**Our Case Number:** ABP-319306-24

**Re:** Proposed development of Cavan Town Sports Campus  
in the townlands of Kilnavara, Lurganboy (Loughtee Upper By), Creighan and Rosscolgan in Cavan  
Town.

**R.E. Application to An Bord Pleanála for approval under Sections 175 and 177AE of the Planning and Development Act 2000 (as amended) and the Planning and Development Regulations 2001 (as amended) by Cavan County Council for Cavan Regional Sports Campus**

Figure 1 - Extract from Site Location Map A2156-100-02. Our house and property is outlined in green

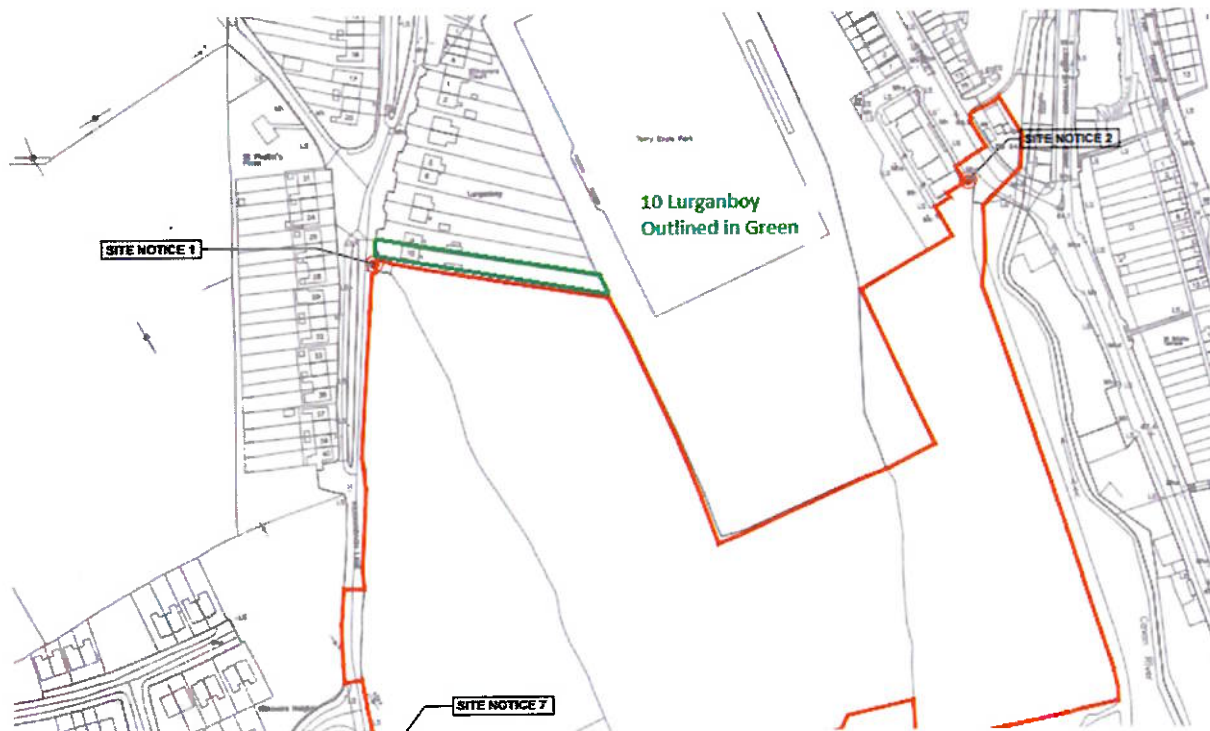
We are the property owners of 10 Lurganboy, Cavan, H12 W012 . Our property is the last house on the Eastern side of Kilnavaragh Lane and will bound the proposed new development's North-Western boundary for circa 85m, along the entirety of our Southern boundary.

Figure 2 - Extract from A2156-100-10 - Tower flood light locations.

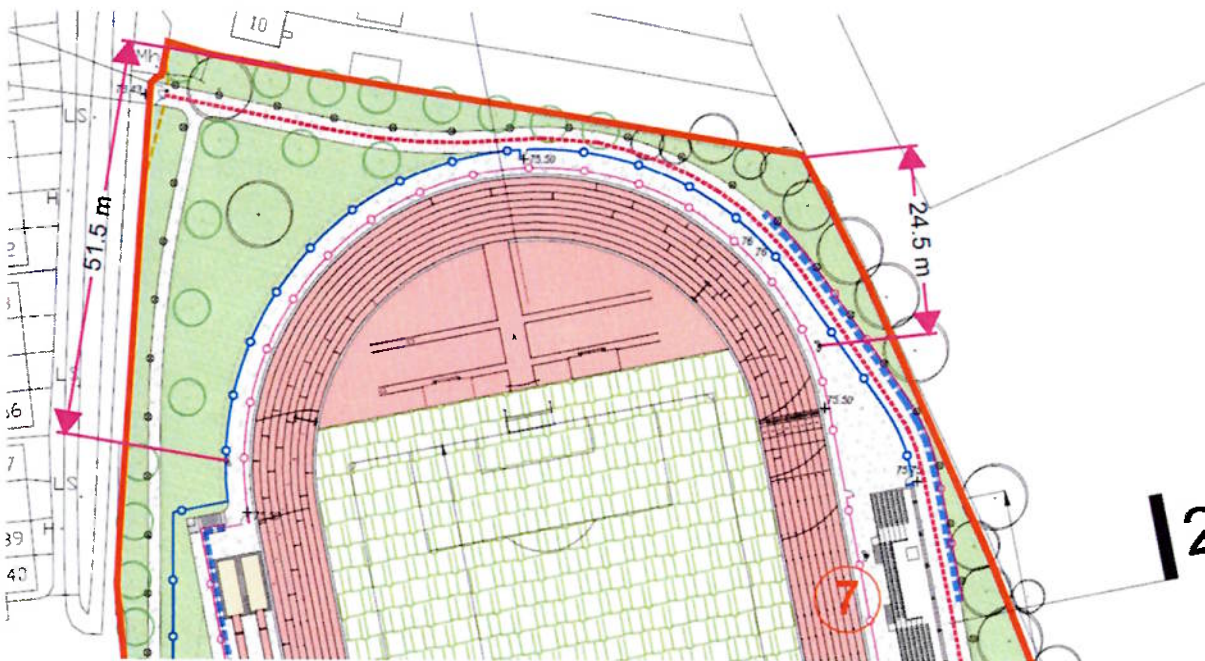
It is also noted that the layout drawing A2156-100-11 shows three number lighting columns along each of the longitudinal sides of the running track, however the 9955-JCP-ZZ-00-DR-E-63003-P02 drawing shows lighting columns at each end of the running track, roughly six (6) metres from our boundary. It is not clear which set of locations were used to assess the flood lighting design (if there is any) and impacts of same as part of the EIAR.

Figure 4 - Extract from A2156-100-11. Section 1B location

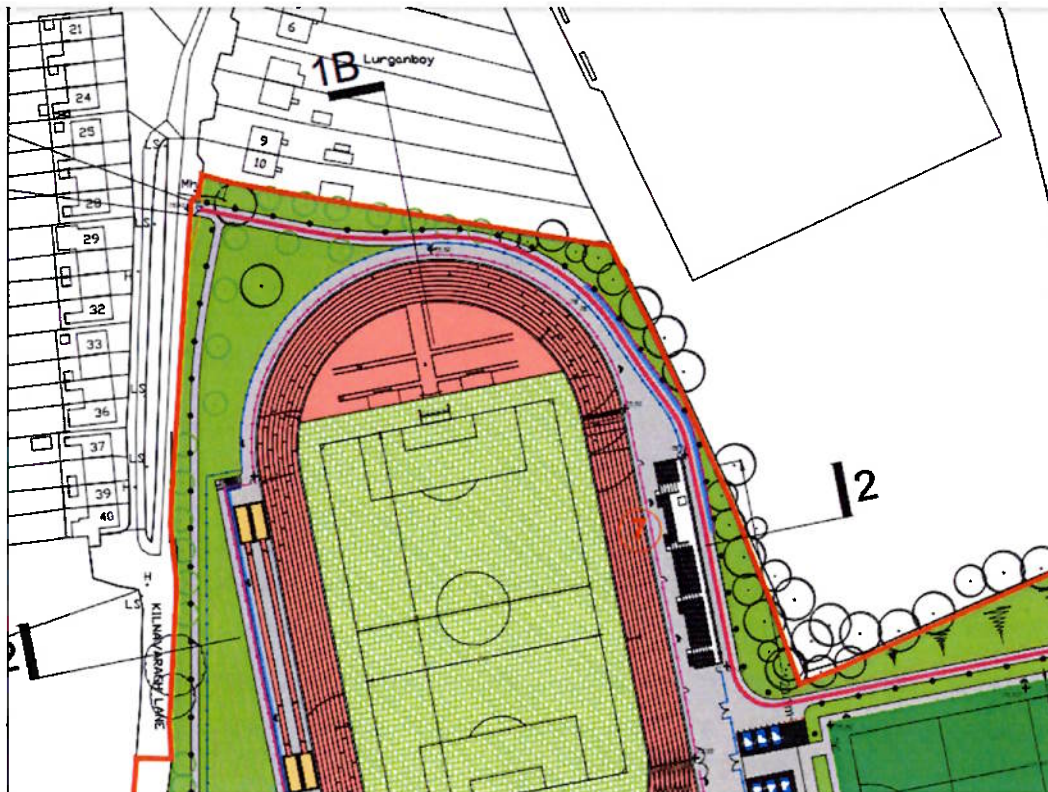
2. Accuracy of information. Some information within the EIAR do not appear to be accurate. For example, the section line shown on drawing A2156-100-11 showing section line 1B and the corresponding section 1B on drawing csc-mca-xx-zz-dr-a-4101, do not allow for an appreciation of the impact of the levels, size and scale of the development adjacent to my property.

It is not possible to assess the visual impact of the development as the drawings are not consistent with each other. The general layout drawing, A2156-100-11, shows the location of section line 1B, extending through a number of properties to the north. The section line is facing Kilnavaragh lane. Drawing CRSP-MCA-00-00-DR-C-1800-P1 shows earthworks cut and fill levels, moving from cut to fill north to south across the location of section line 1B. The sections provided however are not along section 1B as it does not correlate with the earthwork cut and fill levels, does not show any boundary walls, does not show fence lines, pathways, pitch boundaries, floodlight towers etc. It is also questioned what building is shown on 1B of csc-mca-xx-zz-dr-a-4101, as the elevation and scale of the spectator stand does not match that of csc-mca-xx-xx-dr-A-2005.
